Work Order ID 92718

Item Name: Crosstube Turning Detail

DART AEROSPACE LTD		Work Order:	92718
Description: Crosstube Assembly (205/212/412 High Fwd)		Part Number:	D212-664-141
Inspection Dwg: D212-664-141 Rev: D		Page 1 of 2

DRAWING NO. D212-664-141	TITLE XTUBE ASSY (205/212/412 HI FWD)	REV. D	DART AEROSPACE LTD ENGINEERING ORDER		D.E.O. NO. D212-664-141-D-1	SHEET NO. SHEET 1 OF 2	SCALE NTS
DRAWN	CHECKED	MFG. APPR.	APPROVED	DE APPR.			
DATE 11.04.07	DATE 11.04.11	DATE 11.04.12	DATE 11/04/12	DATE 11.04.12

**D212-664-141/-141B
ASSEMBLY DETAIL**

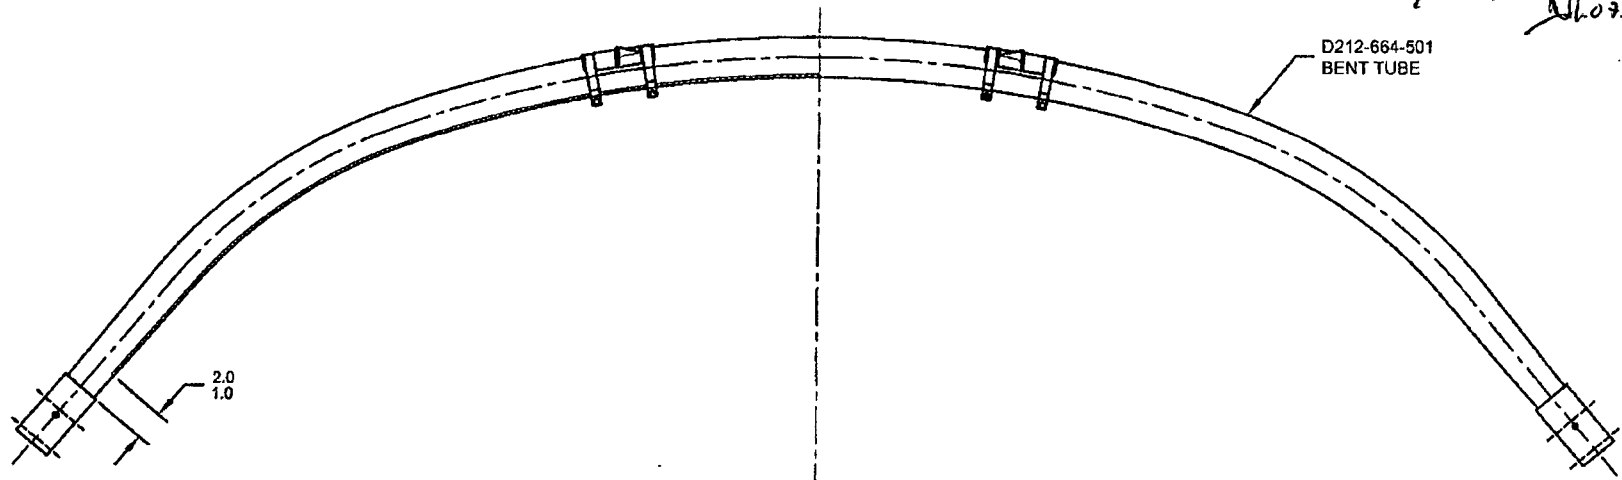
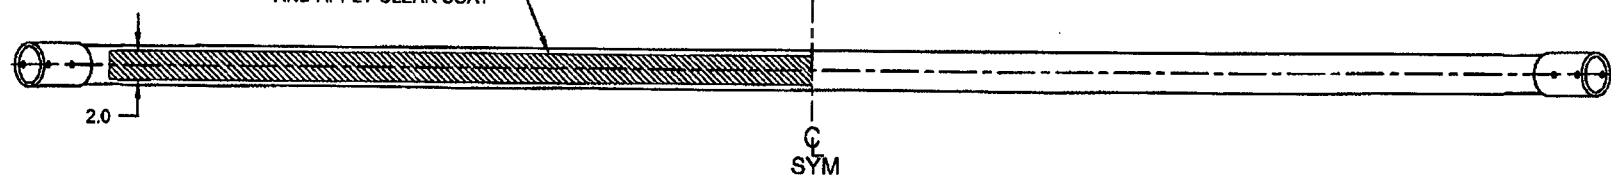
PURPOSE:

ADD AN INSPECTION WINDOW TO UNDERSIDE OF CROSSTUBE.

NOTES 2 OF SHEET 1 IS AMENDED AS FOLLOWS:

- 2) FINISH: CHEMICAL CONVERSION COAT PER DART QSI 005 4.1
PRIME INSIDE AND OUTSIDE PER DART QSI 005 4.2
MASK UNDERSIDE OF CROSSTUBE AS SHOWN (HATCHED AREA) AND
PAINT OUTSIDE PER DART QSI 005 4.2
REMOVE MASKING AND APPLY CLEAR COAT

- 2) FINISH: CHEMICAL CONVERSION COAT PER DART QSI 005 4.1
PRIME INSIDE AND OUTSIDE PER DART QSI 005 4.2
PAINT OUTSIDE PER DART QSI 005 4.2

MASK AREA PRIOR TO PAINTING,
REMOVE MASKING AFTER PAINT
AND APPLY CLEAR COAT
